Proposal #23: 1197-00-70, WISC 2021 042
Spoooner - Minong
Trego Interchange
USH 053
Washburn County

This is Addendum No. 01, which provides for the following:

ADDENDUM NO. 01
PROJECT ID 1197-00-70
November 30, 2020

Addendum No. 01
 ID 1197-00-70
 Revised Sheet 968
 November 30, 2020

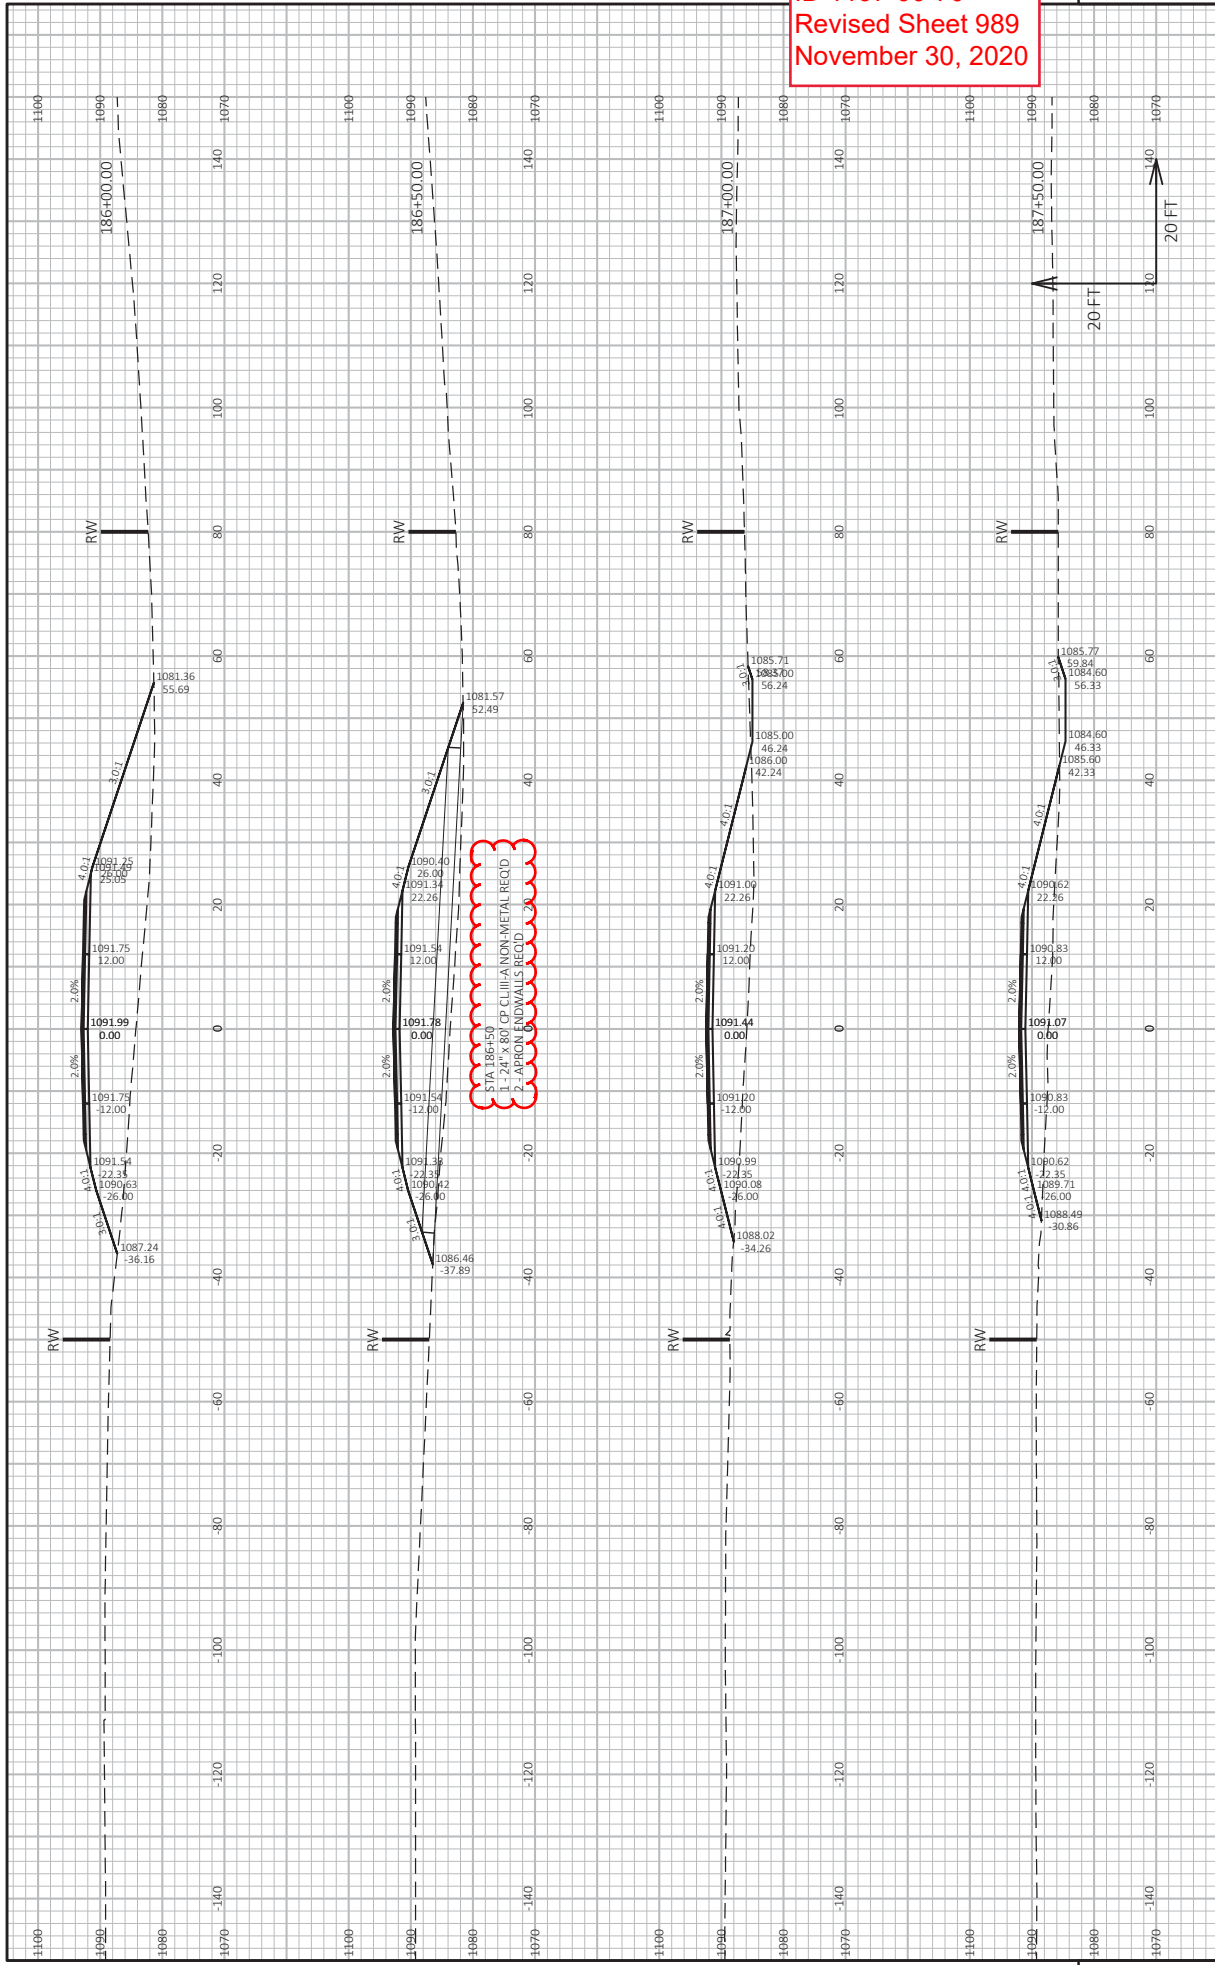
Revised Plan Sheets	
Plan Sheet	Plan Sheet Title (brief description of changes to sheet)
118	Storm Sewer – USH 63 – Pipe material update
119	Storm Sewer – USH 63 – Pipe material update
347	Miscellaneous Quantities – Pipe material update
349	Miscellaneous Quantities – Pipe material update
357	Miscellaneous Quantities – Update to bid item
372	Miscellaneous Quantities – Pipe material update
374	Miscellaneous Quantities – Pipe material update
409	Plan and Profile Sheet – Pipe material update
411	Plan and Profile Sheet – Pipe material update
412	Plan and Profile Sheet – Pipe material update
707	Structure B-65-56 – Updated quantity for fence
782	Structure R-65-3 – Updated quantity for Concrete Masonry Retaining Walls
968	Cross Section - Pipe material update.
989	Cross Section - Pipe material update.
995	Cross Section - Pipe material update.
